Wybunbury Parish Council Response to the public consultation on HS2a November 2015 design consultation Revised documents.

3.0 HS2 Phase 2a Design Refinement Consultation Response.

Map 1

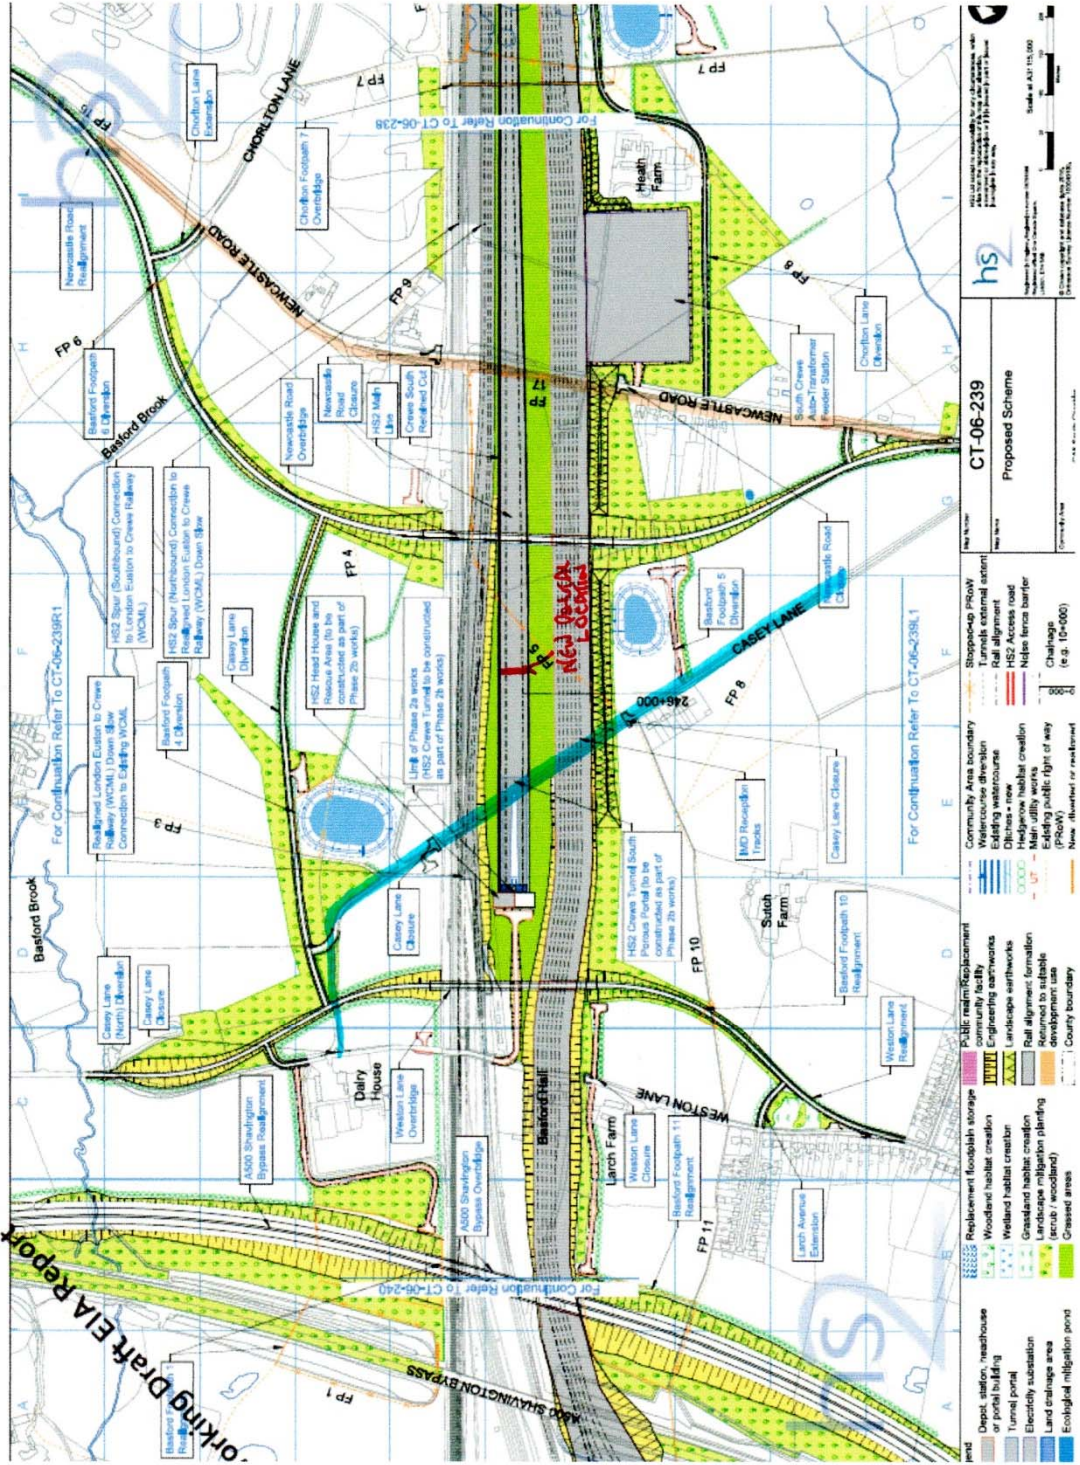
That the tunnel portal entrance be moved even further South by approximately 150m “as shown in Red on map 1”, this will allow Casey lane to pass over the top of the tunnel in the same route as at present “as marked blue in map 1”, this would save the construction of a new railway crossing using up good quality agricultural land & effecting the residents of Casey Lane and Newcastle Rd.

This would also allow for the Newcastle Rd Bridge to be lengthened “ as marked orange on map 1”, so totally doing away with the proposal for a new diverted Newcastle Road , the removal of the need to replace both Casey Lane and a section of the current Newcastle Road would produce a cost saving which could be used for mitigation measures.
